Staff Report to the Planning Commission

PSP2024-0034 and PTP2025-0002

Office Retail Building

3200 S. Rochester Rd.

Site Plan

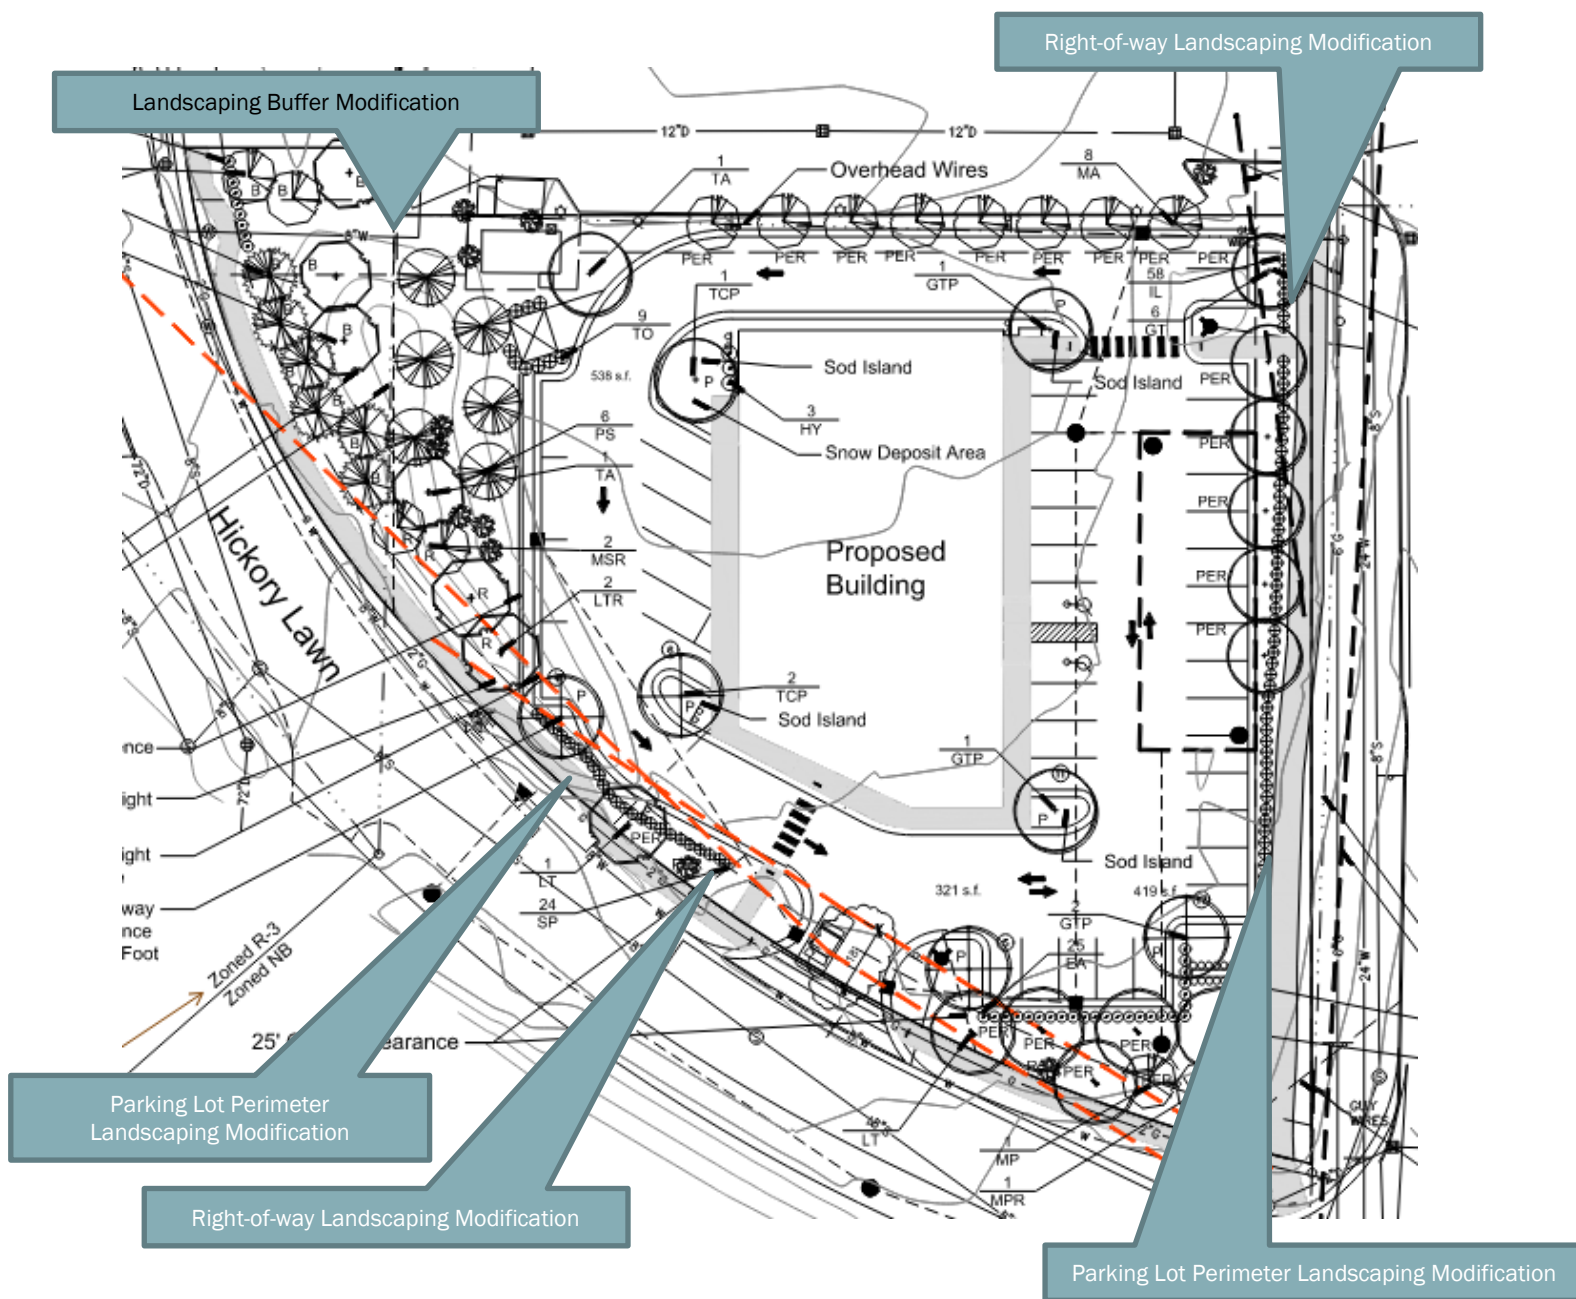
The site plan does not currently propose the installation of a bicycle rack. It may be advantageous for a bicycle rack to be added to the site plan to be consistent with the City's proposed ordinance amendment currently being considered. The parking island at the south end of the building may be an appropriate location. The bicycle rack should be consistent with the City's adopted streetscape plan.

The applicant is seeking modifications to the right-of-way landscaping requirements along both S. Rochester Road (1) and Hickory Lawn (2); modifications for the parking lot perimeter landscaping along both S. Rochester Road and Hickory Lawn (3 and 4); and a modification for the required greenbelt between the proposed site and residential property to the west (5), as discussed further below.

The Zoning Ordinance requires a total of seven (7) shade trees and four (4) ornamental trees along the 254 feet of S. Rochester Road frontage. The applicant has provided one (1) shade tree at this time, so they are requesting a modification of a total of six (6) shade trees and four (4) ornamental trees for the Rochester Road right-of-way frontage. The required hedge row along the majority of S. Rochester Road has been provided. There appears to be conflicts with the City's required clear vision area and the existing pathway extending onto the subject property which affect the applicant's ability to provide the required number of trees in this location. The clear vision area is a result of the access drive from the property to the north and the clear vision area required from the intersection of Hickory Lawn and S. Rochester Road. The applicant has proposed to pay six (6) trees into the City Tree Fund.

The Zoning Ordinance requires a total of twelve (12) shade trees and seven (7) ornamental trees along the 429 feet of frontage along Hickory Lawn. The landscape plan proposes a total of three (3) shade trees and no ornamental trees. Therefore, the applicant is requesting a modification of a total of nine (9) shade trees and seven (7) ornamental trees for the Hickory Lawn frontage. This frontage also is somewhat impacted by the presence of clear vision areas along with the proposed sidewalk extending onto the subject site. In addition, it should be noted that the westernmost portion of the site is zoned residential which would not necessarily require the planting of right-of-way landscaping. The applicant has proposed paying nine (9) trees into the City Tree Fund.

The perimeter parking lot planting requirements with the Zoning Ordinance require a total of seven (7) shade trees and five (5) ornamental trees based on the current site plan configuration. Of these required trees, a total of six (6) shade trees have been provided and five (5) ornamental trees (planted along the north property line instead of along S. Rochester Rd.), therefore, the applicant is requesting a modification of one (1) shade tree to not be planted and the five (5) ornamental trees to be planted along the north property line instead of along S. Rochester Rd..

The perimeter parking lot planting requirements with the Zoning Ordinance require a total of six (6) shade trees and four (4) ornamental trees based on the current site plan configuration. Of these required trees, all have been provided, however, three (3) of the required ornamental trees have been planted along the north property line, therefore requiring a modification.

The buffering requirements for when a nonresidential site abuts a residential property requires the installation of a six (6) foot tall masonry wall. The applicant is proposing a six (6) foot tall vinyl privacy fence. The subject site is currently split zoned. The majority of the site is zoned NB Neighborhood Business, however, the westernmost portion of the site is zoned R-3 One Family Residential. The applicant has provided extensive landscaping along the western portion of the site, on both the Business and One Family Residentially zoned portions of the property. The applicant has proposed a privacy fence amongst the landscaping proposed rather than a masonry wall. The fence proposed follows the zoning line which transects the property in a north/south fashion from the northern property line, extending south to within 10 feet of the right-of-way for Hickory Lawn.

1. Address all applicable comments from other City departments and outside agency review letters.
2. A bicycle rack consistent with the City's Gateway and Streetscape Master Plan must be provided.
3. Provide a landscape bond in the amount of \$53,282.00, plus the cost of inspection fees, as adjusted by staff as necessary, prior to the preconstruction meeting with Engineering.

Renderings / Elevations

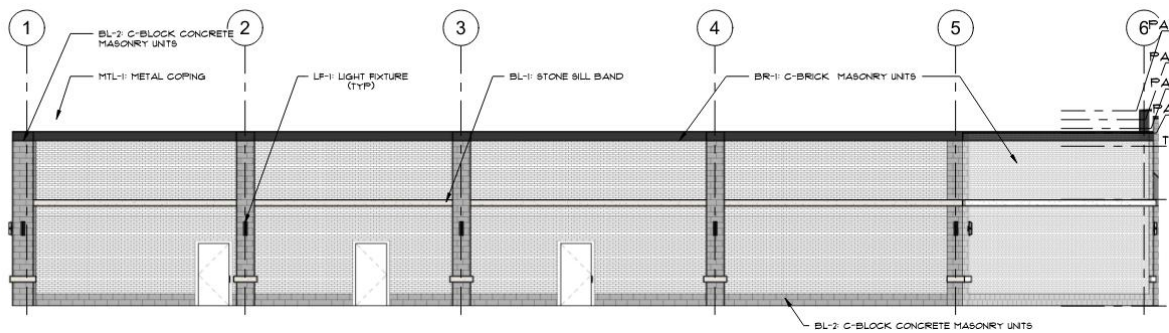
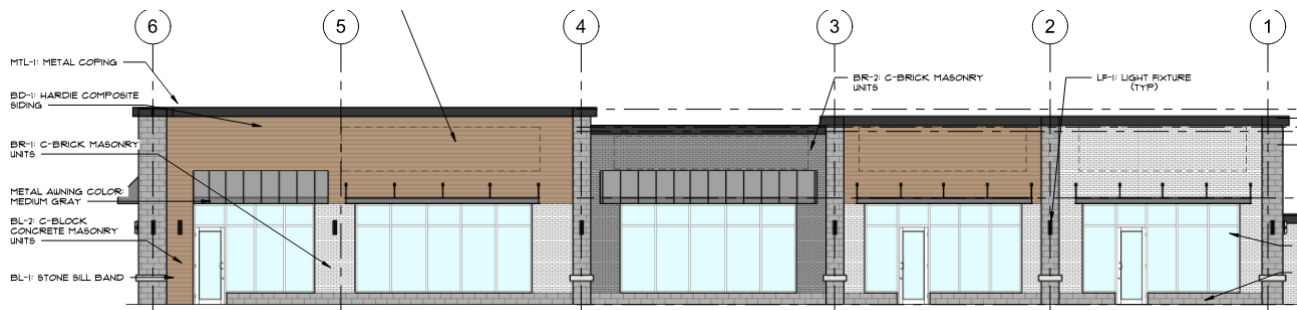
The building architecture provides for a modern design and the building materials include a mix of masonry brick material and wood composite siding. The building materials vary from some of the more traditional building materials seen in the City and should be closely reviewed by the Planning Commission.
